Docket No. 50-346

February 10, 1984

This is in response to your letter dated September 6, 1983 (Log No. 1360), concerning the instrumentation to detect Inadequate Core Cooling (ICC). Toledo Edison provided the schedule for the response on August 9, 1983 (Serial No. 993). Toledo Edison's response for Items 2, 3, 6, 7, 8 and 11 in the Enclosure 2 of your letter was submitted on December 8, 1983 (Serial No. 1003). We have committed that Items 1, 4, 5, 9, 10 and 12 in the same enclosure will be submitted to you by February 10, 1984. Enclosed is Toledo Edison's response to these items, except Item No. 1, as we are waiting for additional data to be supplied by a vendor. It is expected that the response for Item No. 1 will be submitted to you by March 9, 1984.

Docket No. 50-346
License No. NPF-3
Serial No. 1025
February 10, 1984
Attachment

DETAIL "C"
FULL SIZE

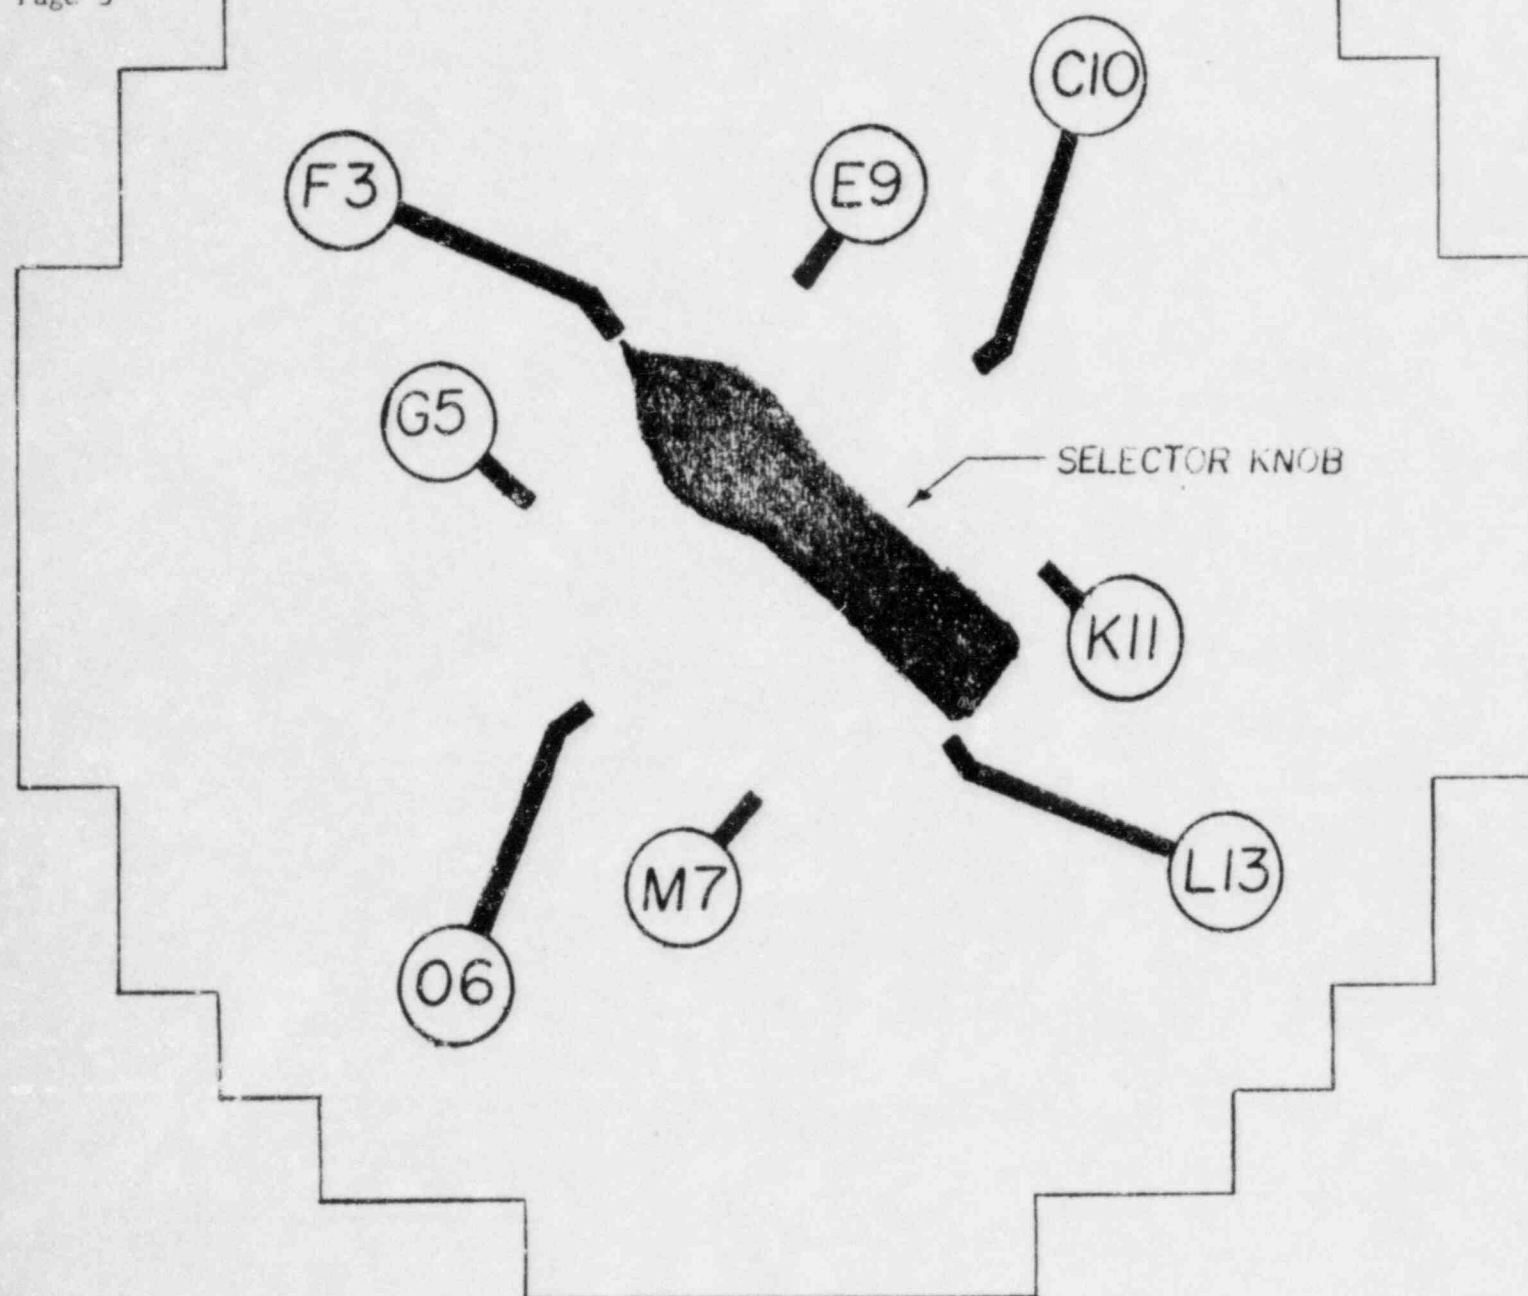
QUESTION: 9. Figures 1 and 2 show TI4627 and TI4628 as incore temperatures. Is this equivalent to the backup display of core exit temperature and if so where is the channel selector switch located? What type of indicator is used, e.g., digital/LED?

RESPONSE: The core map for the backup display is located at the hand selector switch. It shows the spatial location of the eight thermocouples for that particular channel (see details C&D). The hand switch is used to select one of these temperatures for display on the temperature indicator for that channel (TI4627 for Channel 1, TI4628 for Channel 2). The core maps/hand selector switches and associated temperature indicators for the backup display are located on the Post Accident Indicating Panels (see Figures 1 & 2). Temperature indicators TI4627 and TI4628 are analog indicators with a range of 0-2300°F.
